# 1ST & PIKE

103 PIKE STREET

EARLY DESIGN GUIDANCE 2  
06 FEBRUARY 2018  
DPD #3028428

# 1. TOWER

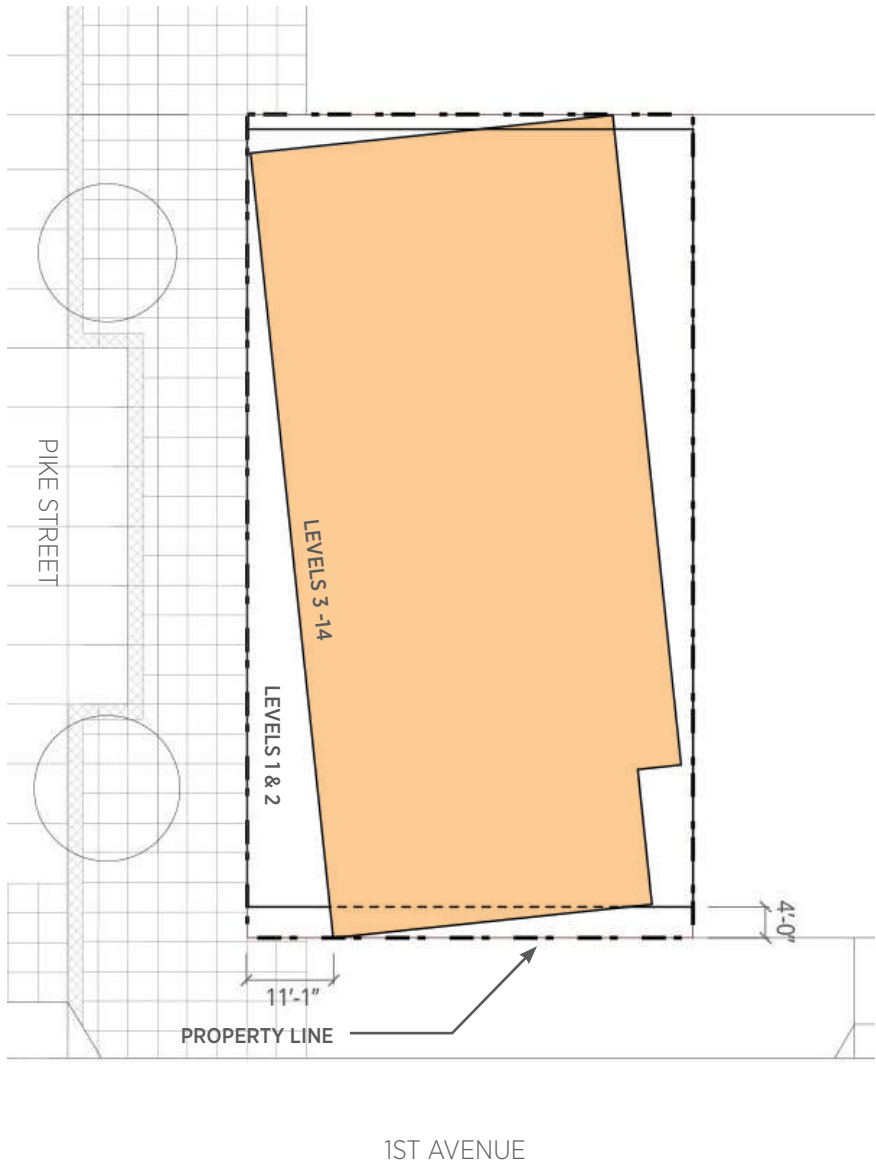
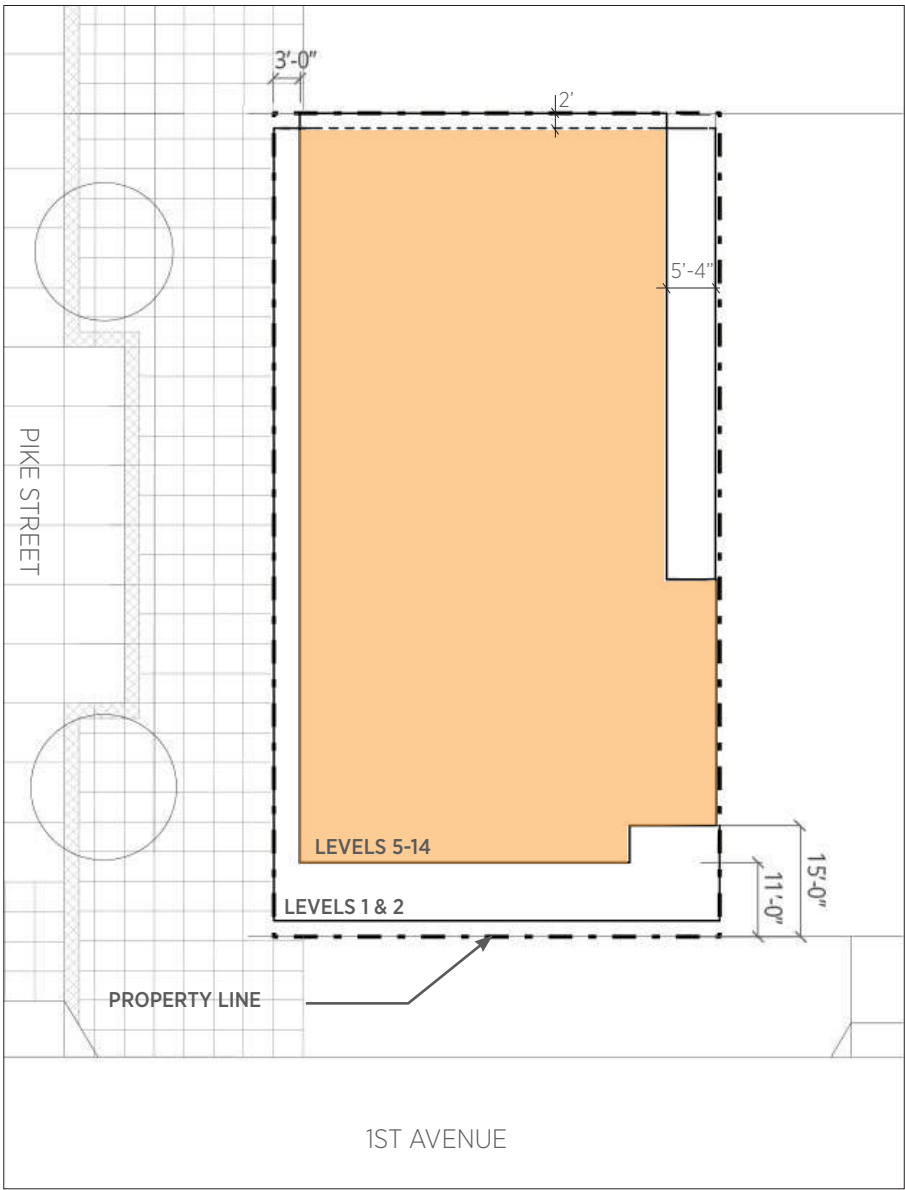
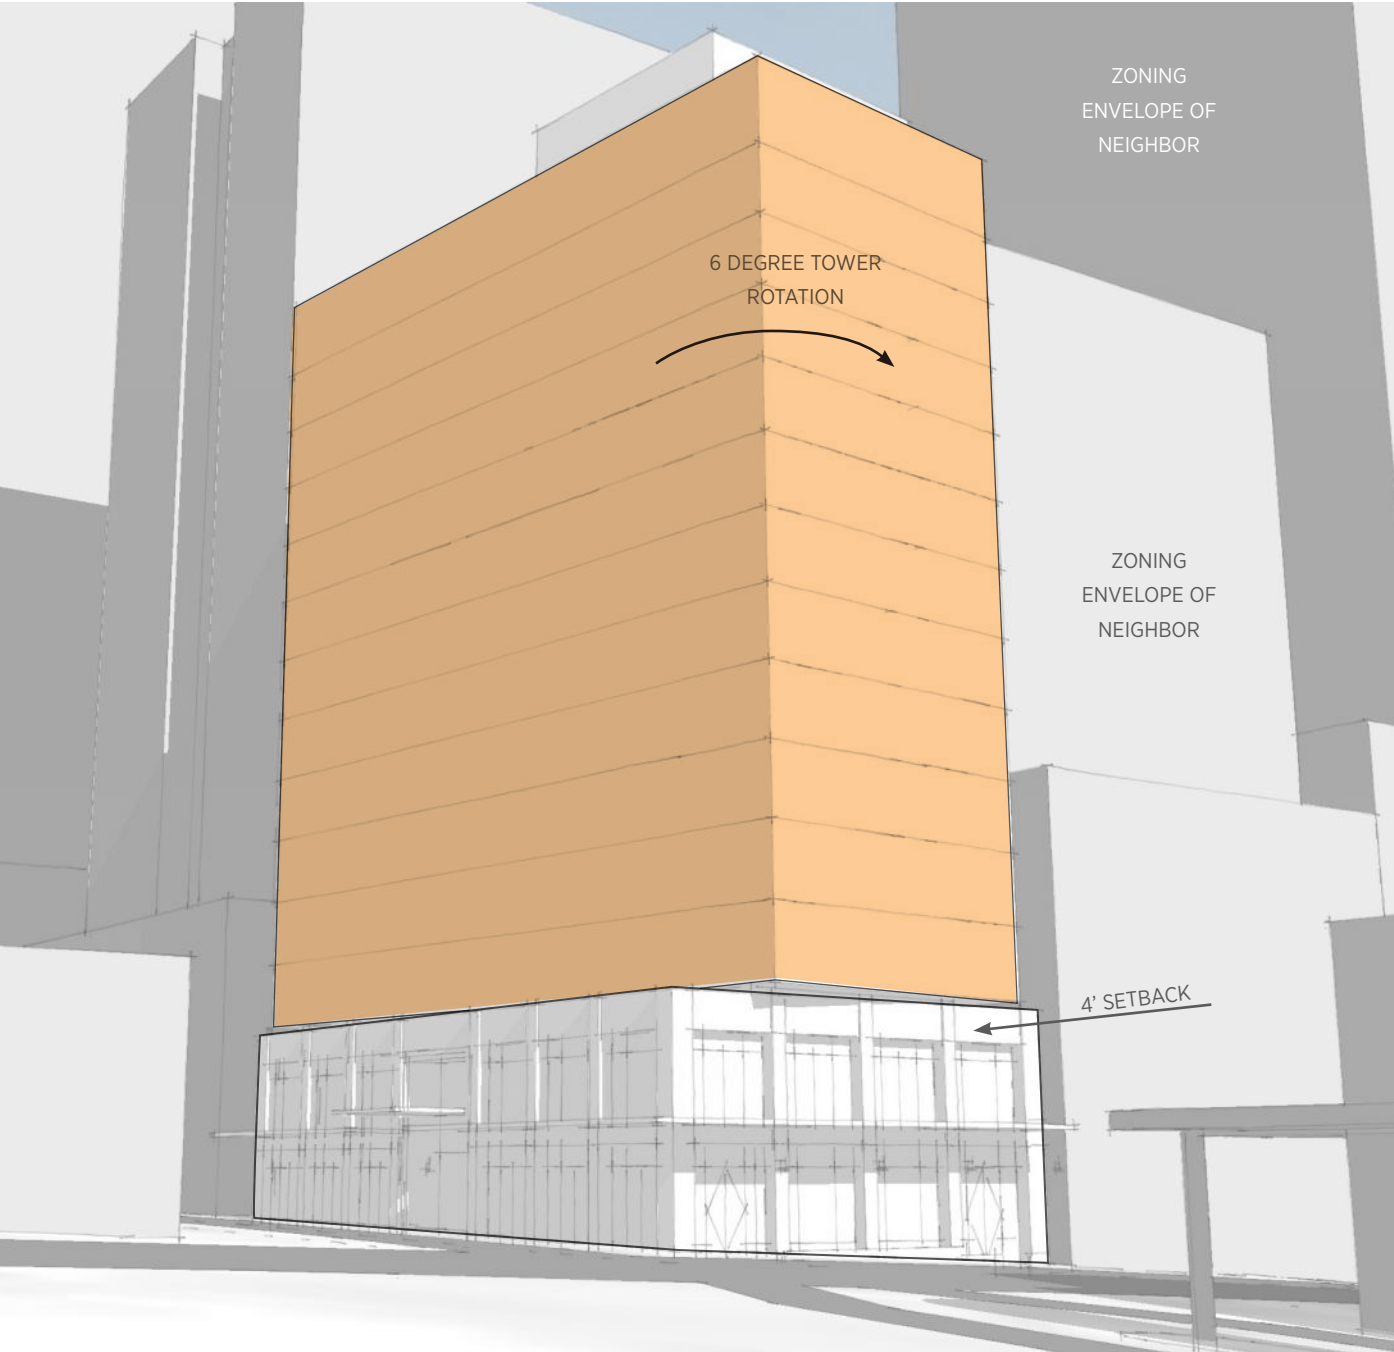
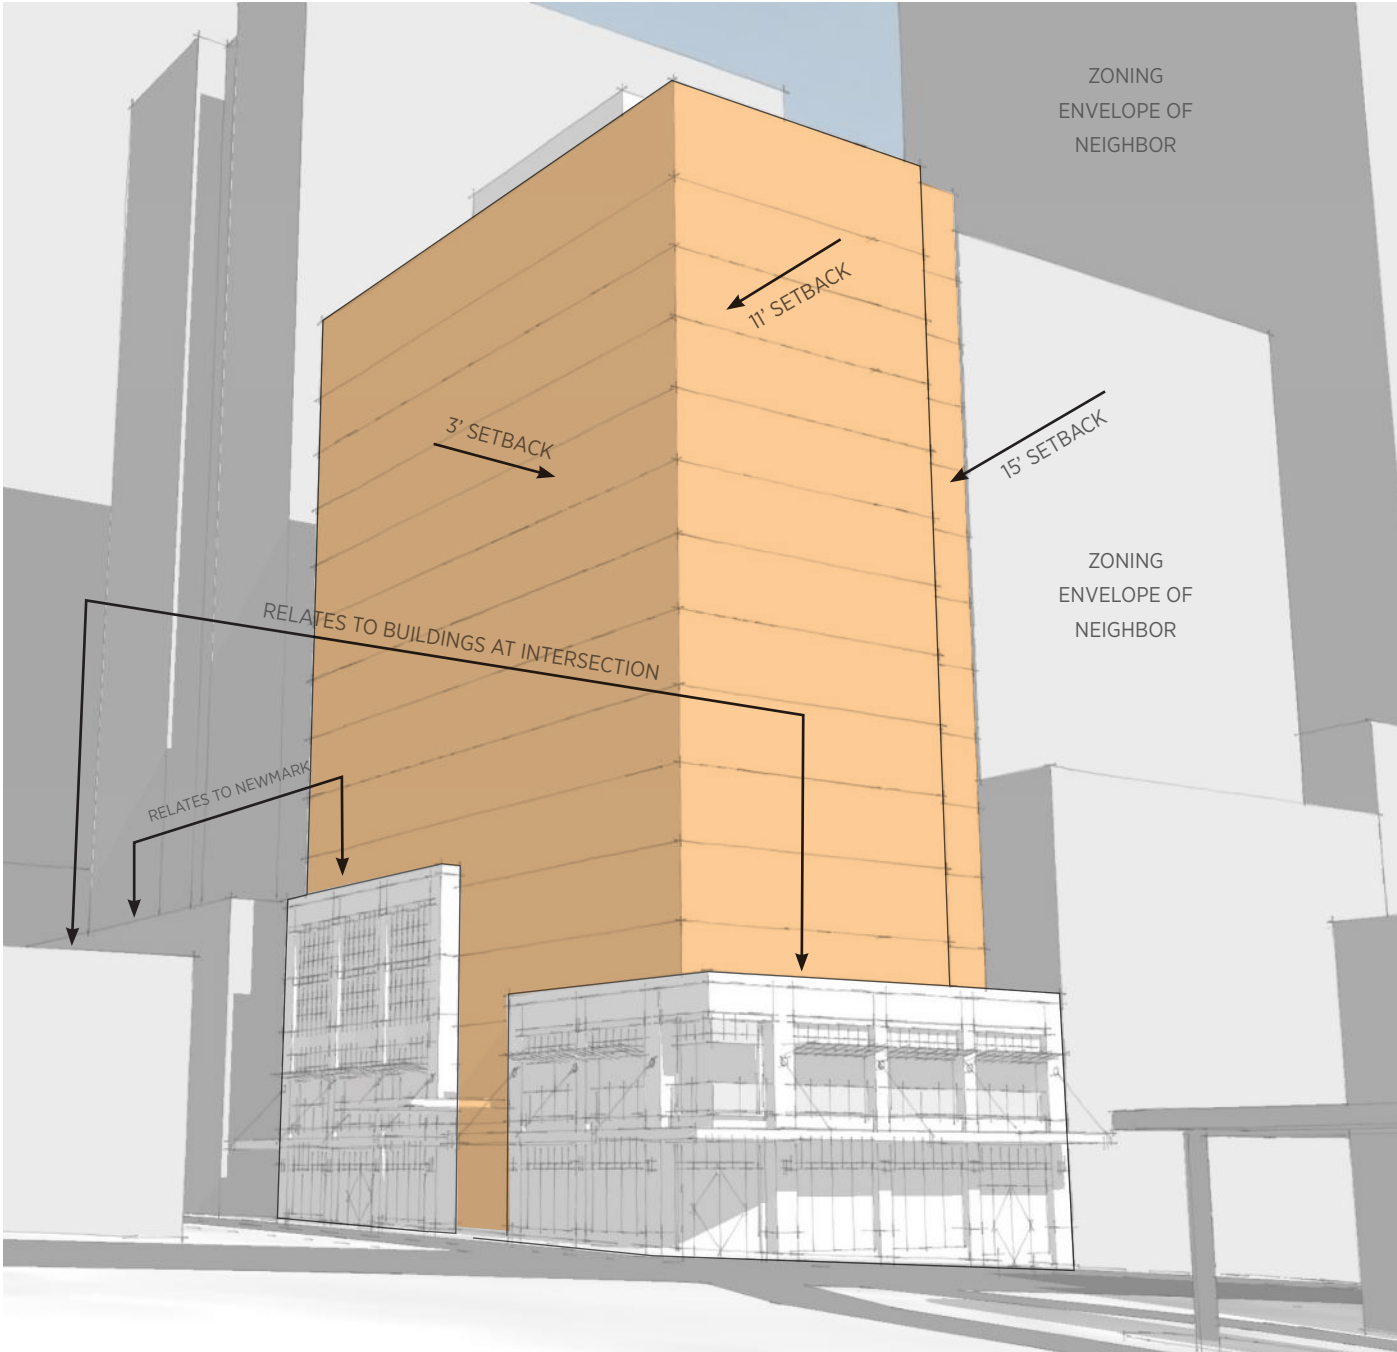
- 1.a.iii. The Board's comments pertaining to the tower were as follows:
- The Board emphasized that the tower massing should set back from the podium on both streets (1st Avenue and Pike Street) and be designed to fade away to respect the existing Market context and preserve existing view corridors. Thus, the Board did not support the requested upper level setback departure as shown. Nor did the Board support the cantilevered tower on 1st Avenue for Concept 3. The Board offered the design team the option of continuing to explore a refined version of the concept 3 design (pivot option) or study/present a new tower massing to the Board at the next EDG meeting.

The tower has been completely redesigned. The pivot has been removed; without the cantilever over the base, it no longer had a visual impact. Voluntary setbacks have been introduced along 1st Avenue and on Pike Street.
